STAFF ANALYSIS

Case No.:	CZ-25-1247294	File ID #: 2024-1442	
Address:	1716 Pleasant Hill Trail, 7778, 7860, 7890, 7900, 7956 & 8024 Pleasant Hill Road	Commission District: 05	Super District: 07
Parcel ID(s):	16-197-03-006, 16-197-03-012, 16-219-01-005, 16-219-01-006, 16-220-01-004 16-220-01-007 & 16 220 01 009		
Request:	Major modification of Conditions #1 and #4 of CZ-18-22130 for the development of single-family detached dwellings within the RNC (Residential Neighborhood Conservation) Zoning District.		
Property Owner(s):	Hybrass Properties, LLC.		
Applicant/Agent:	Hybrass Properties, LLC. c/o Battle Law, P.C.		
Acreage:	95.52 acres		
Existing Land Use:	Single-family dwellings/vacant		
Surrounding Properties:	North: R-100, MU-1 East: RNC, R-85 South: R-85 West: R-85		
Comprehensive Plan:	Suburban (SUB)	Consistent	Inconsistent X

Staff Recommendation: TWO-CYCLE DEFERRAL

CONCEPT PLAN
FOR
PLEASANT HILL

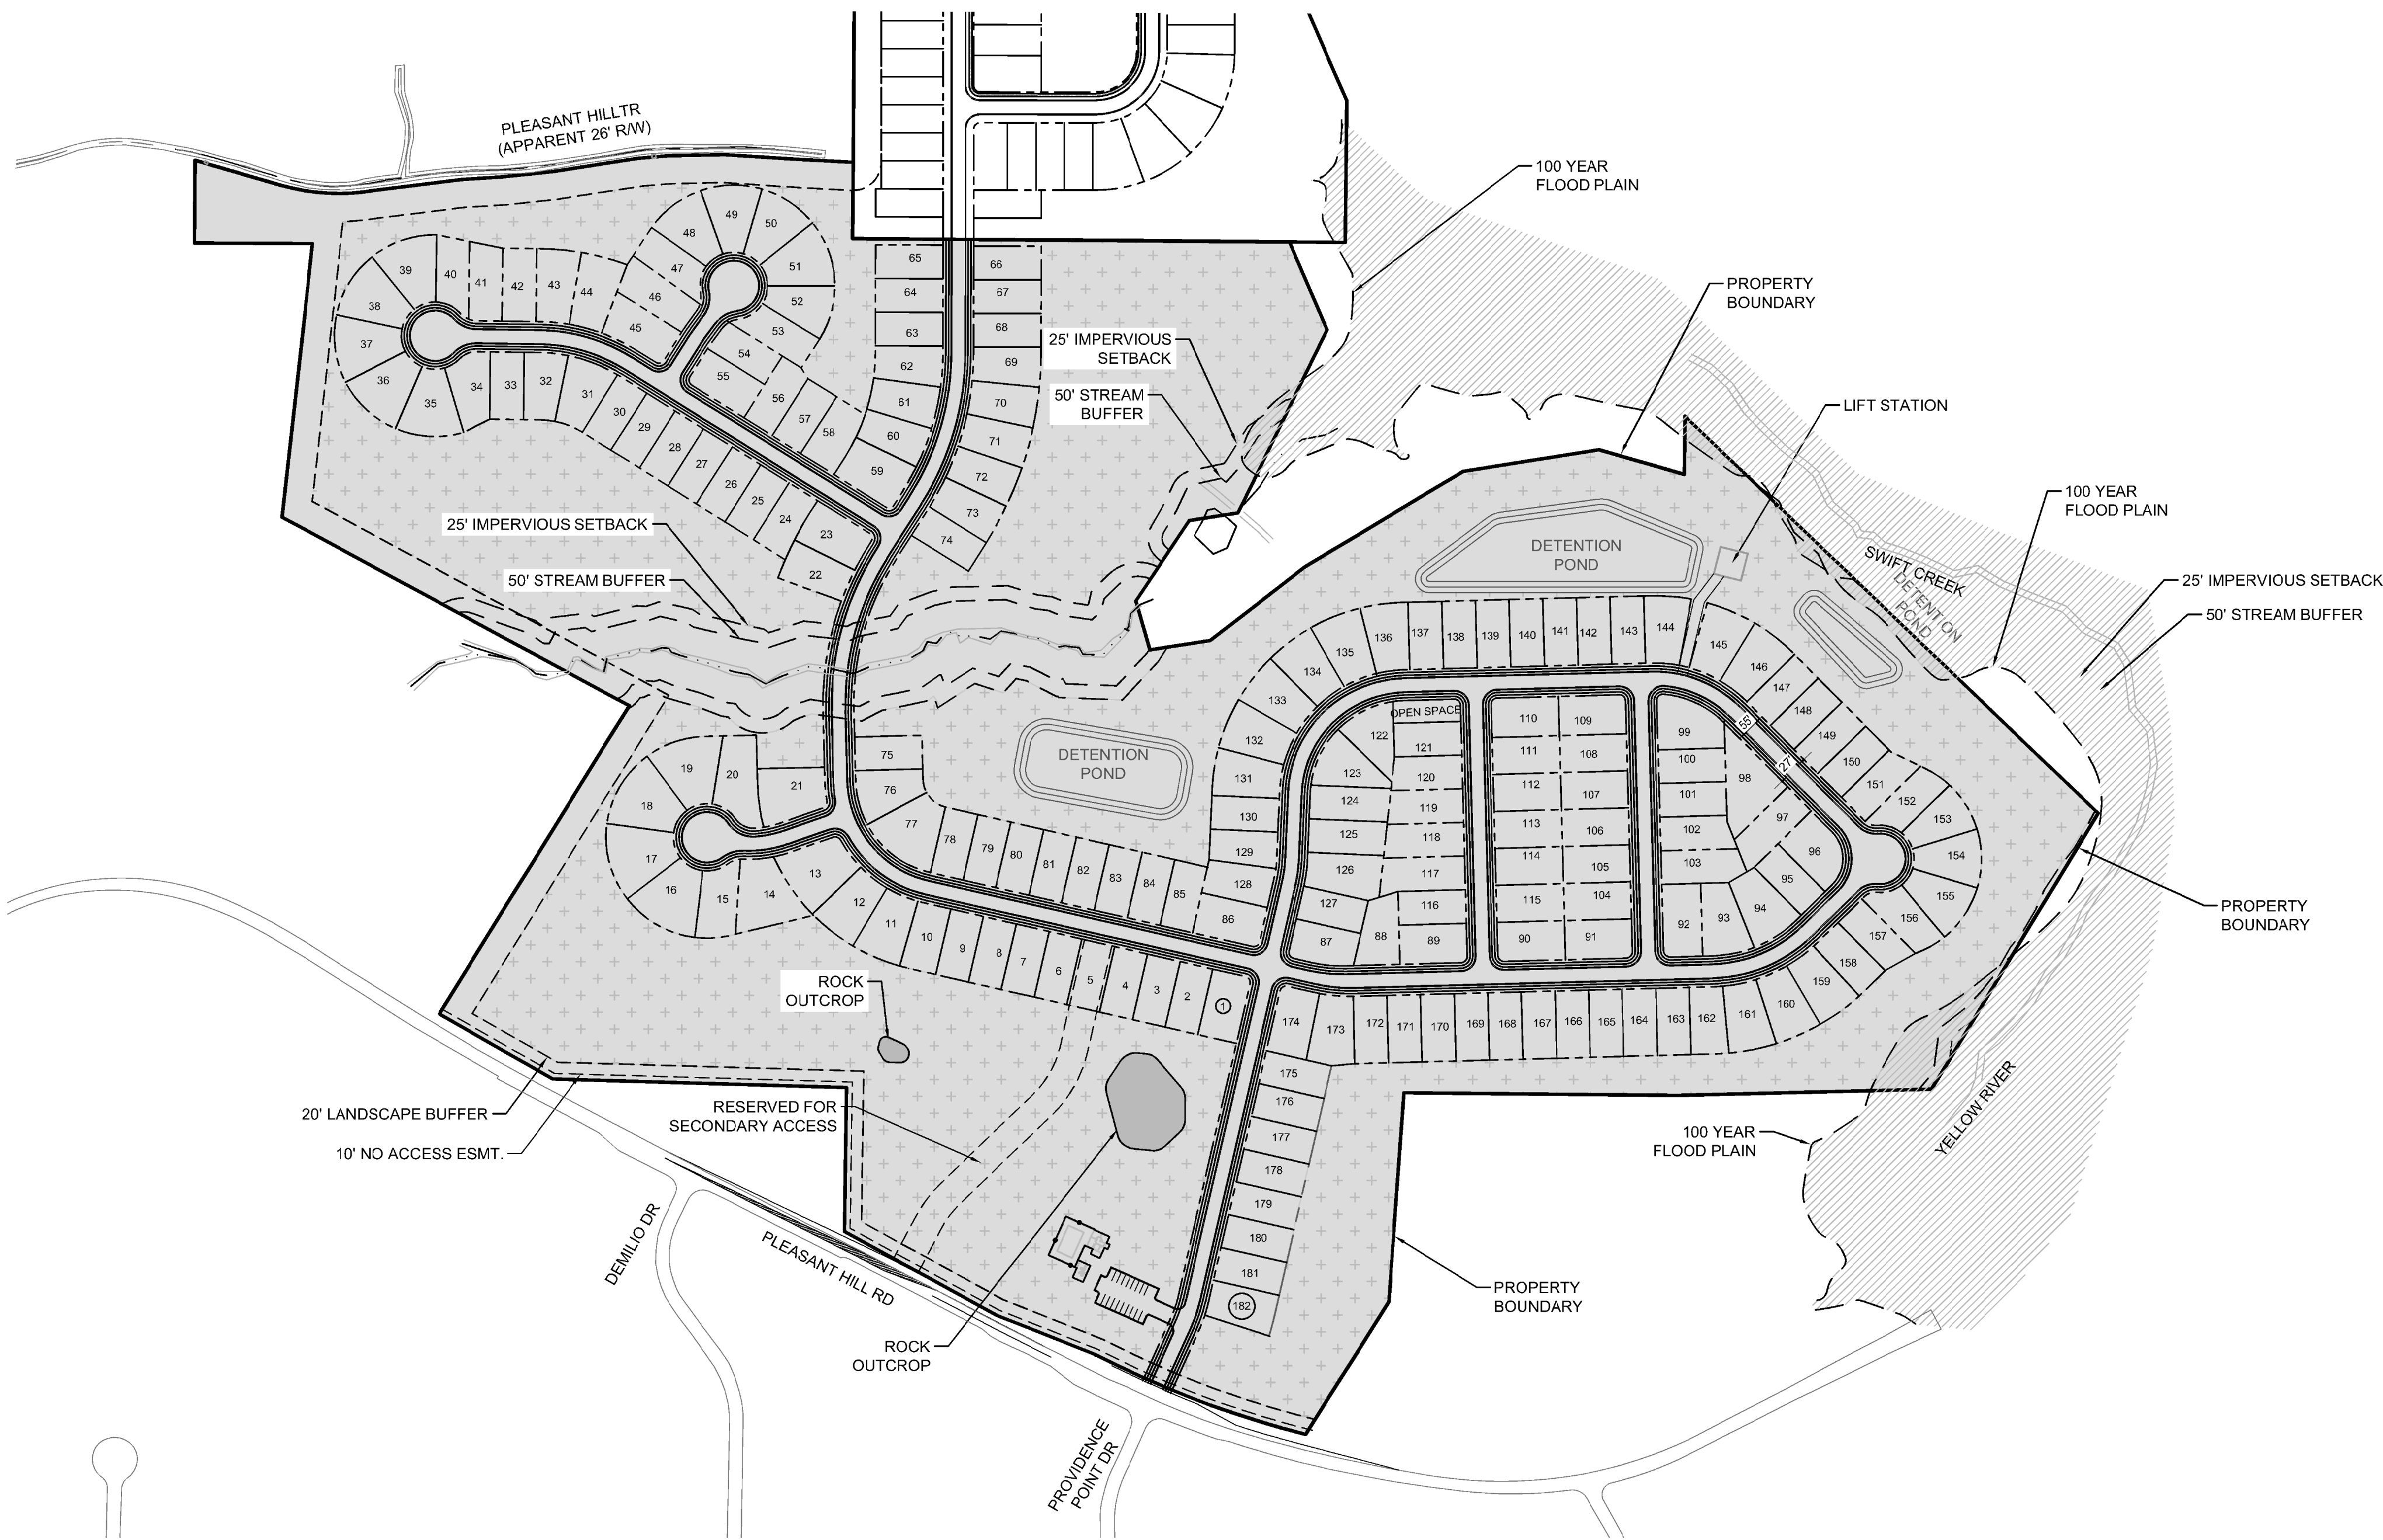
A modification of Condition #4 would relocate the originally proposed access points along Pleasant Hill Road to accommodate topography. One of the access points would connect to a proposed subdivision to the north of the development site; notably, however, Current Planning has yet to have received a Sketch Plat application for such a subdivision. An additional access point would be provided only for emergency vehicles. Per the current site plan, only (1) of the three (3) access points would be for regular traffic off of Pleasant Hill Road, which has raised concerns from Staff as well as the surrounding community.

The submitted site plan shows a development that appears to have extreme slopes throughout, as well as having state waters/stream buffers. Meeting this greenspace requirement could pose a challenge for development and could affect lot yield.

N5. CZ-25-1247294 - 7778 Pleasant Hills Road, etc. - Phase 1 has 182 lots and requires 3 access points (Sec. 14-200 (5)). Verify the reserved secondary access point meets the minimum spacing outlined in 14-200 (6) and has the required sight distance. Please see infrastructure requirements in Zoning Code 5.4.3 and Land Development Code 14-190. Pleasant Hill Road is a classified as a minor arterial (45MPH). Requires a right of way dedication of 40 feet from centerline OR such that all public infrastructure is within right of way, whichever greater. Requires at least an 11-foot travel lane with curb and gutter. Requires a 10-foot landscape strip (with at least 5 feet between the back of curb and the sidewalk/path), 6-foot sidewalk with 4-foot bike lanes OR (preferred) 10-foot multiuse path in lieu of sidewalk and bike lane. Street Lighting required. (hefowler@dekalbcountyga.gov). Pleasant Hill Road is classified as a local road. Requires a right of way dedication to 27.5 from centerline OR such that all public infrastructure is within right of
